CLARIFICATION ON PRE-BID QUERIES AGAINST TENDER NO. CGI6849P22

Schematic Flow diagram and Installations between PS10-Barauni and PS5-Noonmati

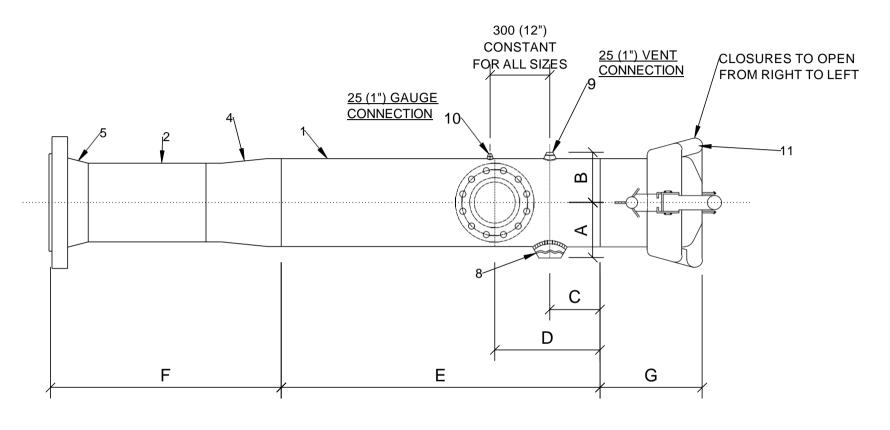
4)	Page 98 of 149 ANNEXURE II	confirm. We request you to share the Schematic diagram/Flow diagram of all 15 pipeline so that bidder can understand the direction of flow/pigging and can properly understand the launcher and receiver names for taking correct dimensions from Annexure II. Please indicate the name of all pumping/receiving stations in the diagram.		Schematic flow diagram is attached herewith

LAUNCHING TRAP

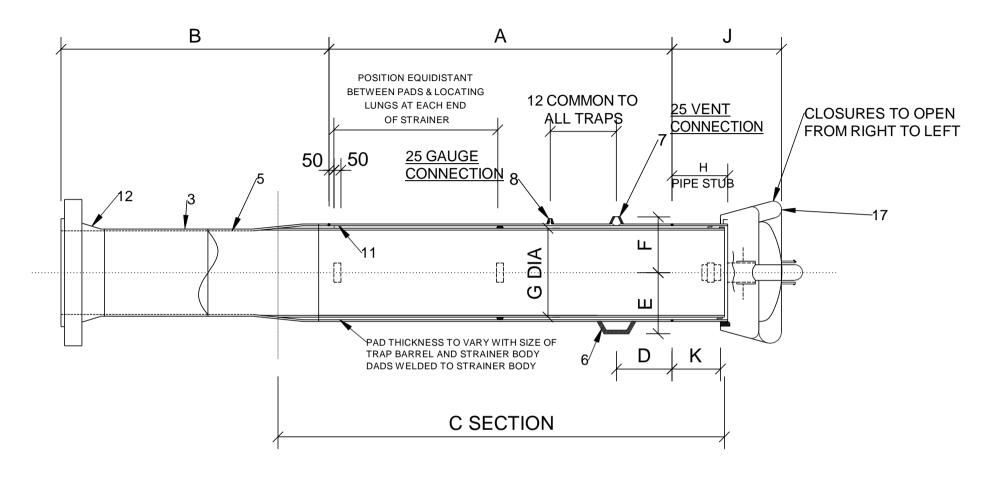
15)	Page 98 of 149 ANNEXURE II	We understand that there is a launcher at PS5 however we are unable to find the drawing of Launcher so please confirmwhich drawing is to be referred for Launcher at PS5.		Attached herewith
